# Addendum

**Project:** Harris County Psychiatric Center Renovation  
Units 1C, 2E, 3B, 3C, 3D, & 3E

**Addendum No.:** 002

**Date:** November 14, 2016

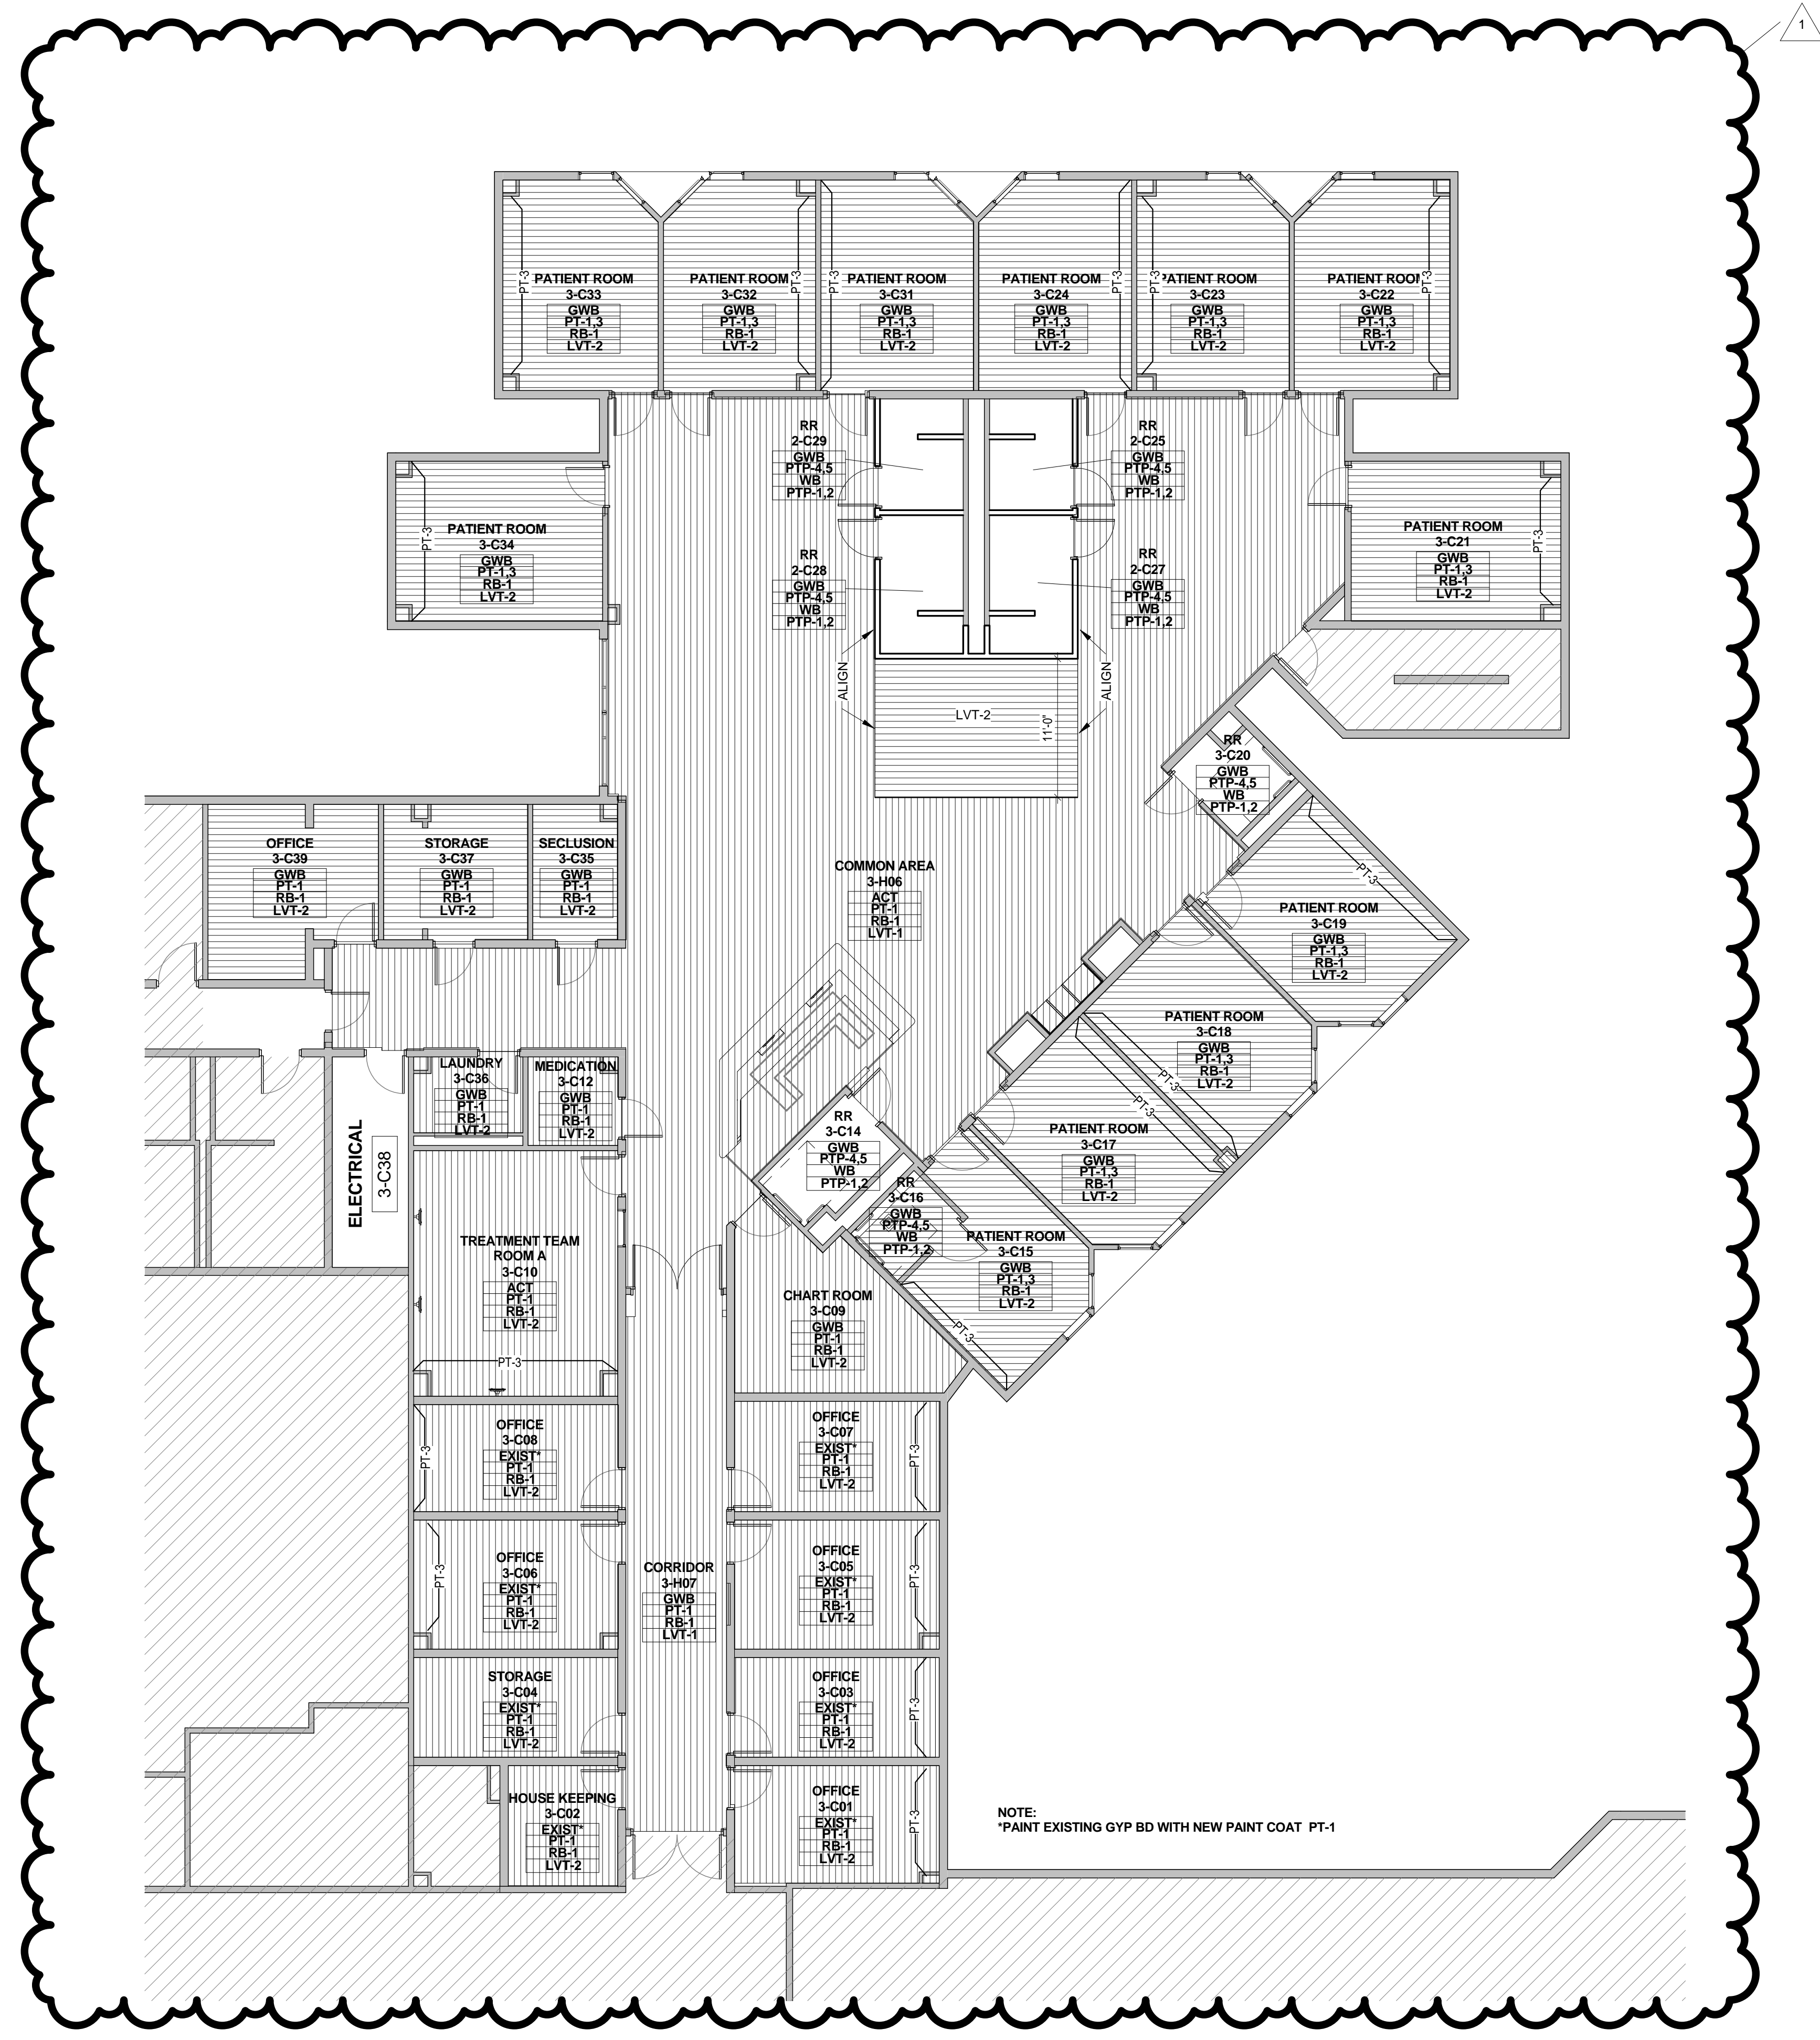
9. Sheet A2.21B, Third Floor Finish Plan – Unit 3B, revised to reflect changes to LVT-1 flooring specification and addition of flooring pattern(s) and grain direction(s) in Common Area. (see attached)

### 1 THIRD FLOOR FINISH PLAN - UNIT 3D

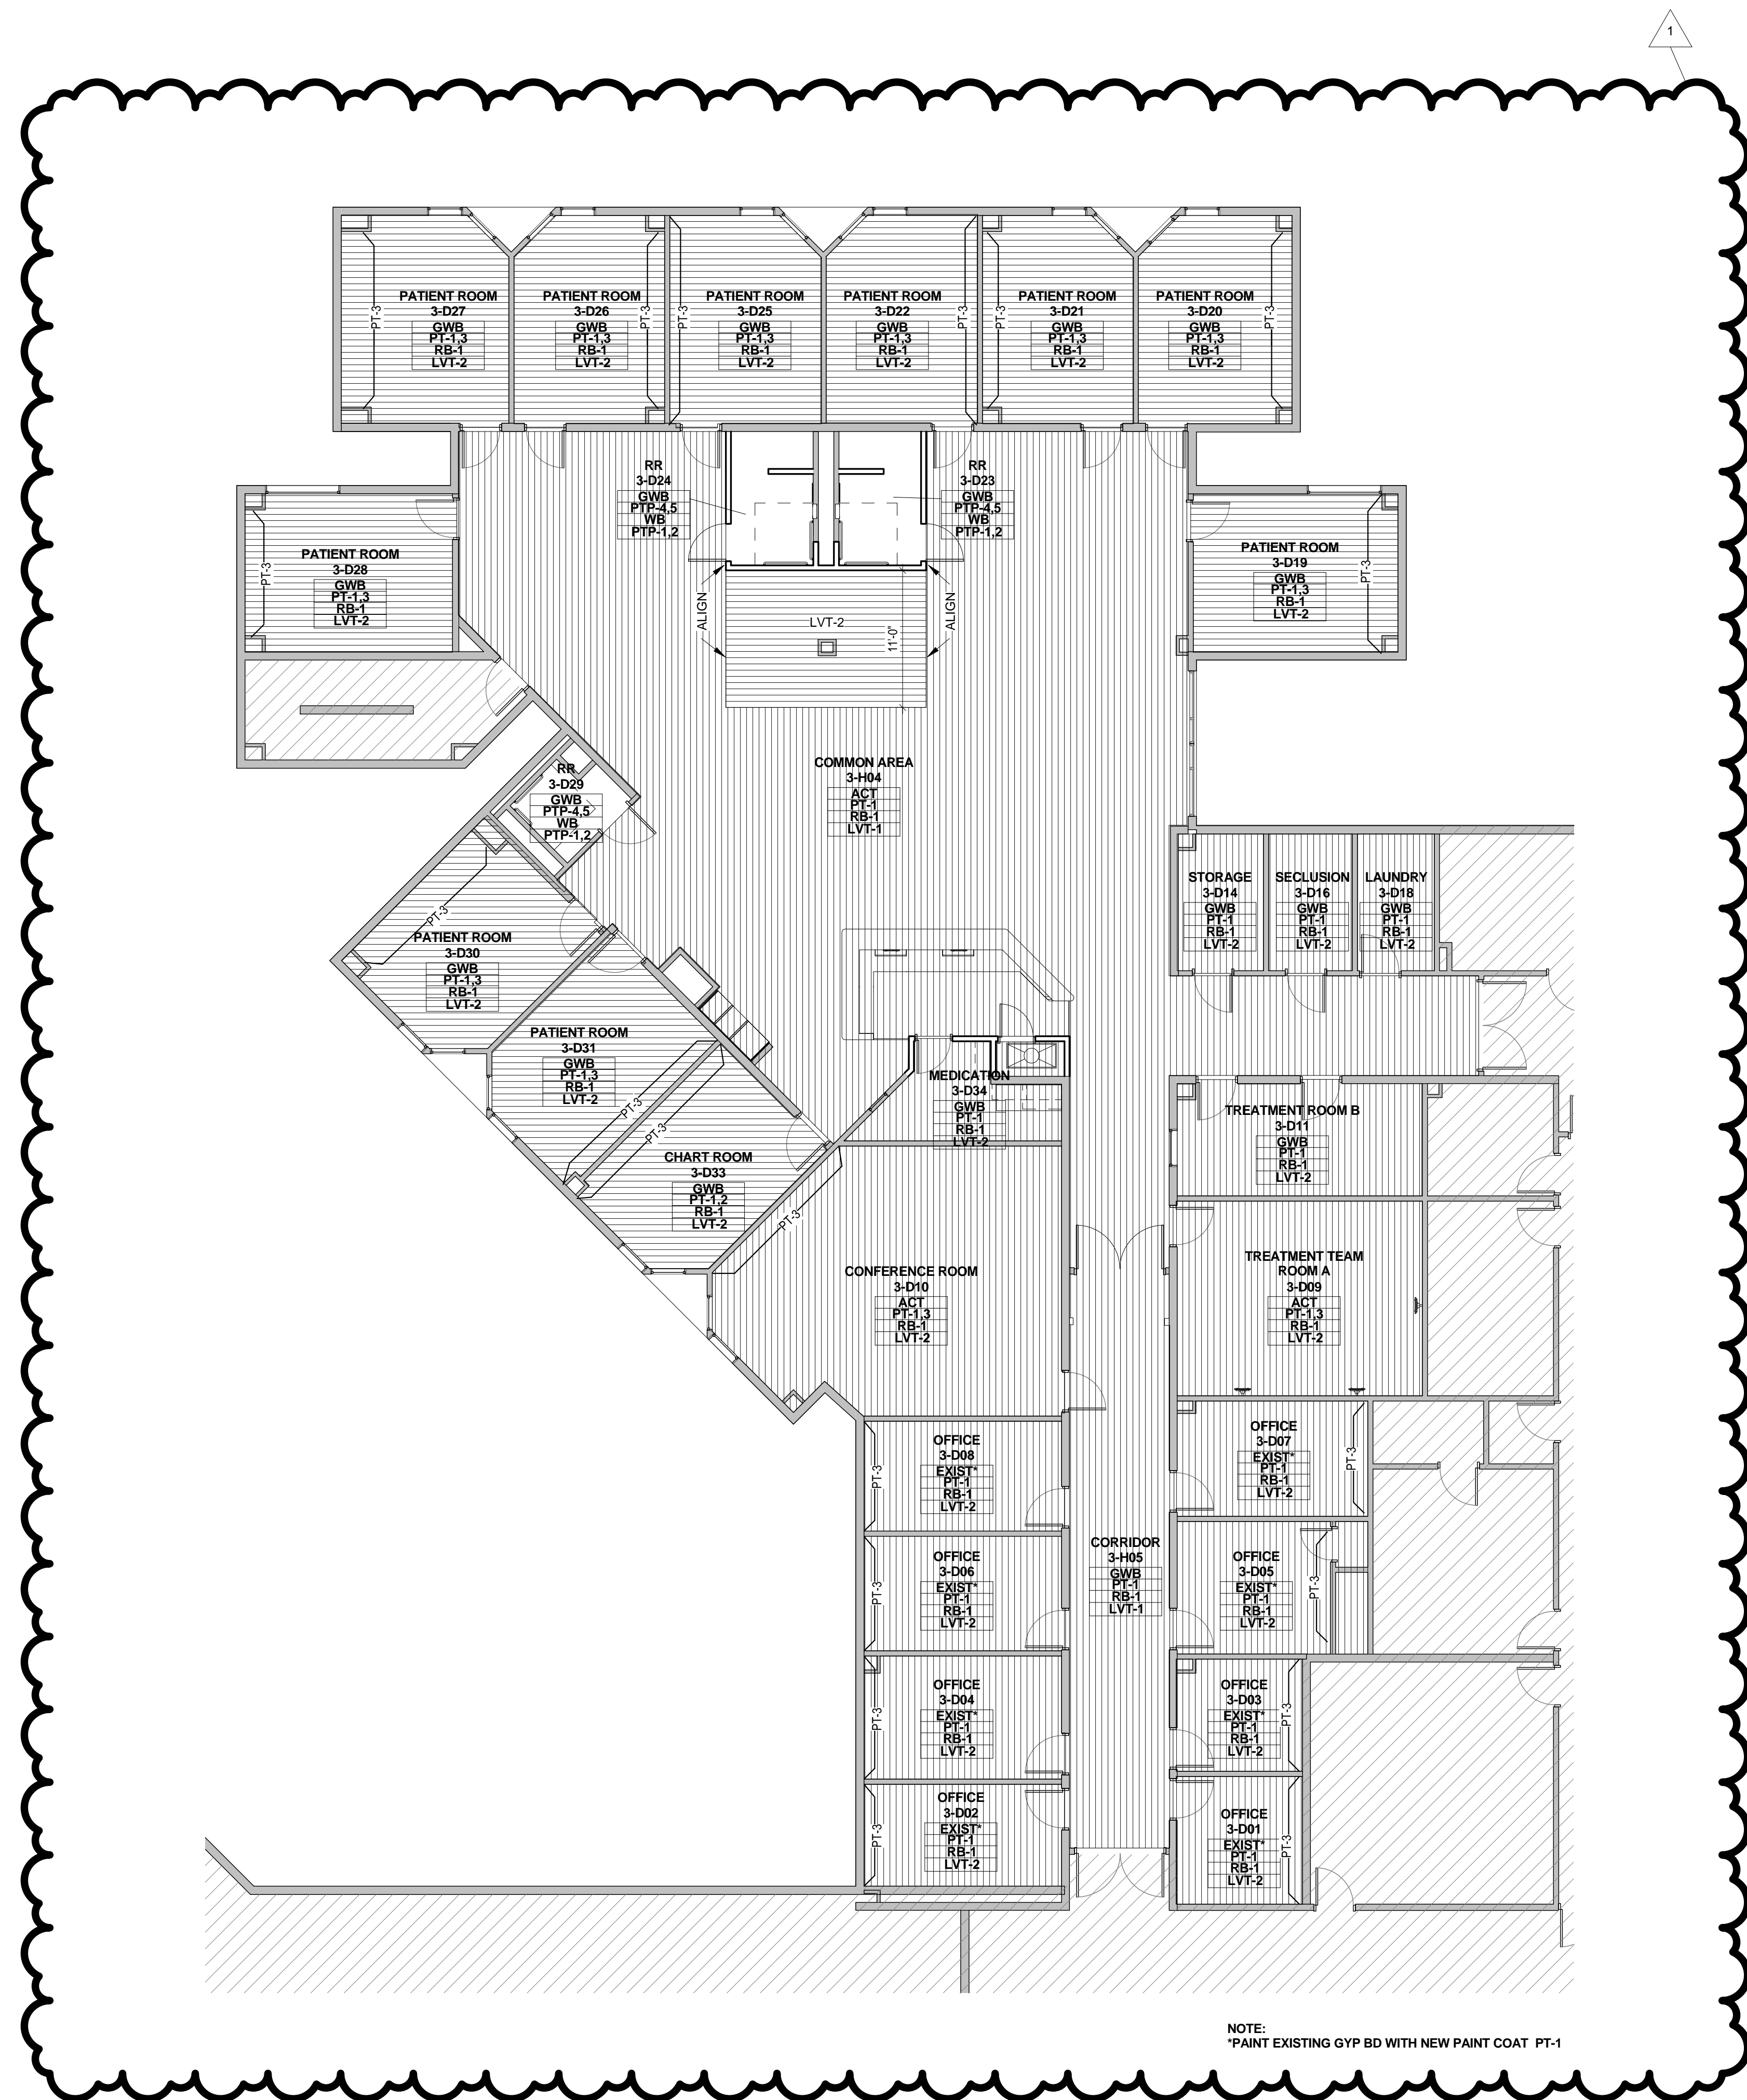
11. Sheet A2.23D, Third Floor Finish Plan – Unit 3D, revised to reflect changes to LVT-1 flooring specification and addition of flooring pattern(s) and grain direction(s) in Common Area. (see attached)

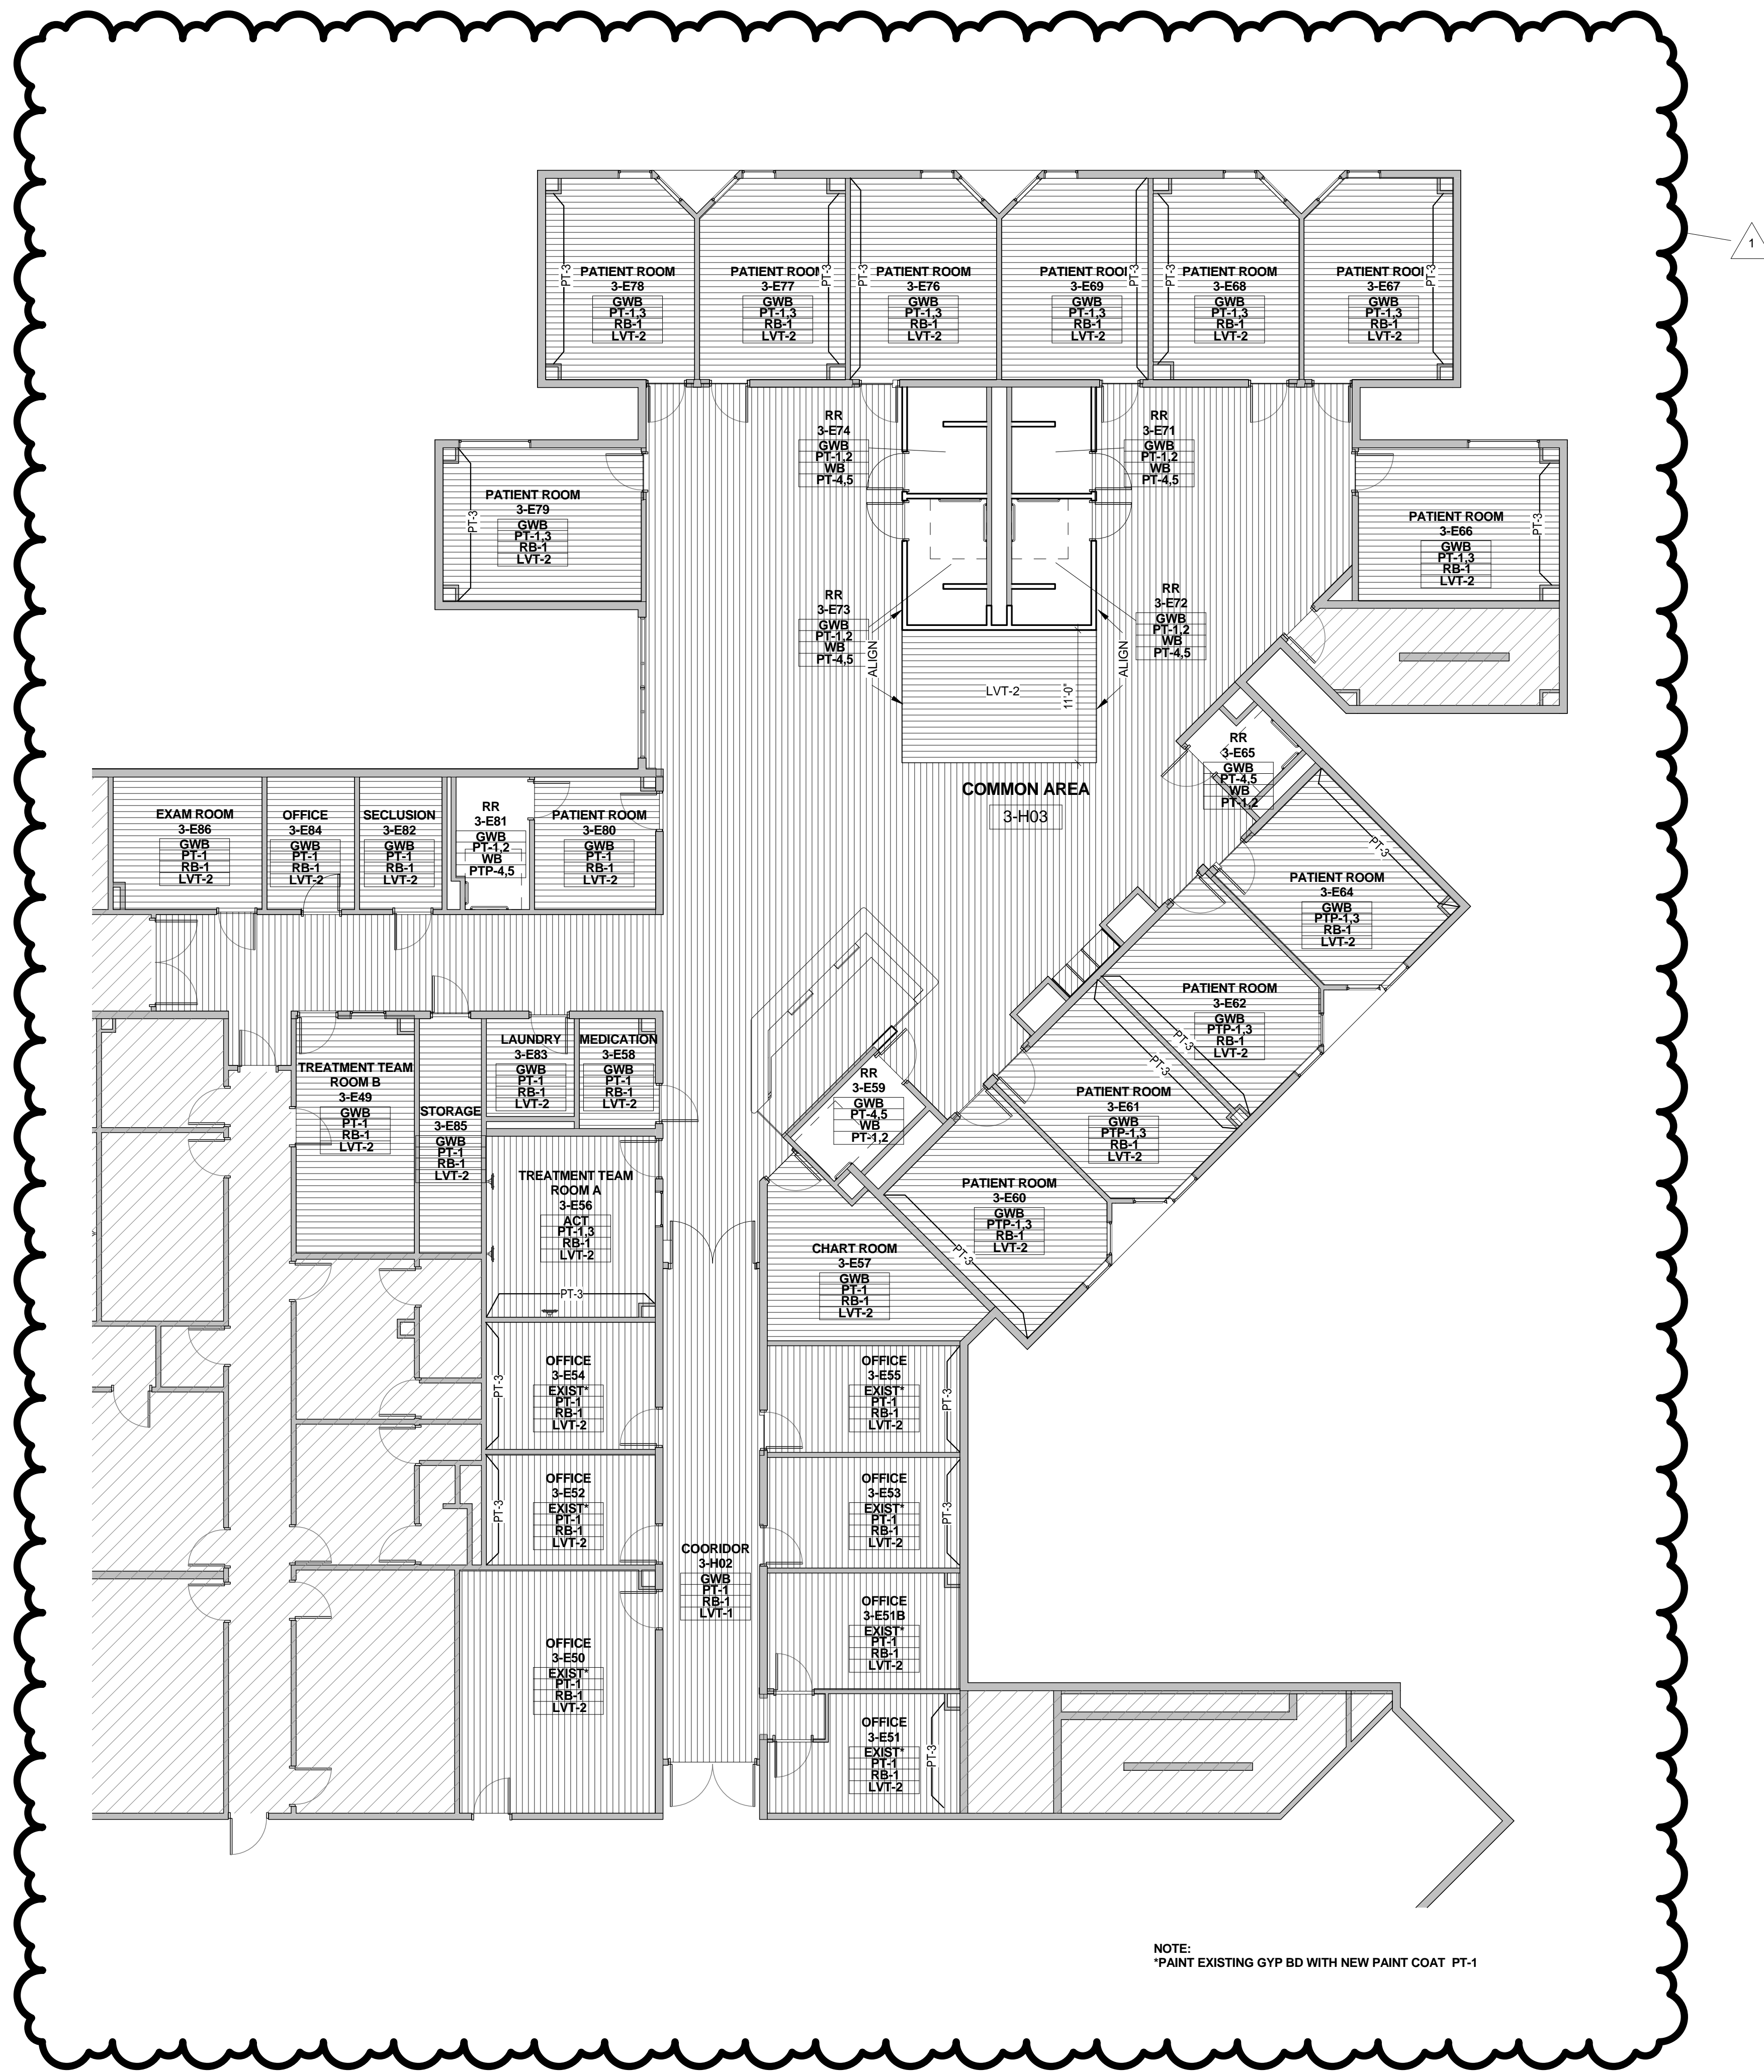
12. Sheet A2.24E, Third Floor Finish Plan – Unit 3E, revised to reflect changes to LVT-1 flooring specification and addition of flooring pattern(s) and grain direction(s) in Common Area. (see attached)
